Batter-to-Battery Connector Cable

M-374-001

(March 2008)

Battery-to-Battery Jumper Cable

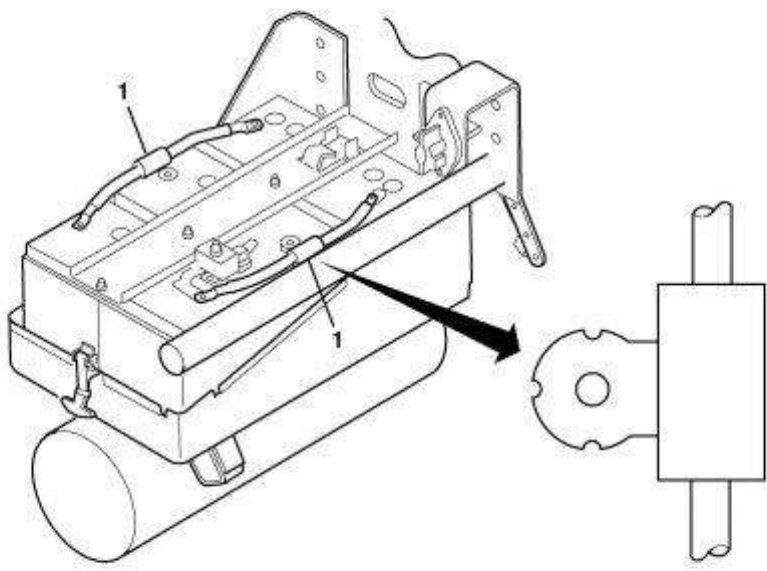
A revised battery-to-battery connector cable (part number 21178749) for chassis equipped with a three-battery arrangement is available through the MACK Parts System. The revised cable, which connects the batteries of a three-battery arrangement together in parallel, does not have the rubberized plastic material moulded over the brass terminal ring on the center terminal. The absence of this material allows stacking of other cables on the battery terminals.

Key	Qty.	Part number	Description	Replaces
1	2	21178749	Cable, battery-to-battery connector, without rubberized plastic moulded over brass ring on center terminal	46MK3972M
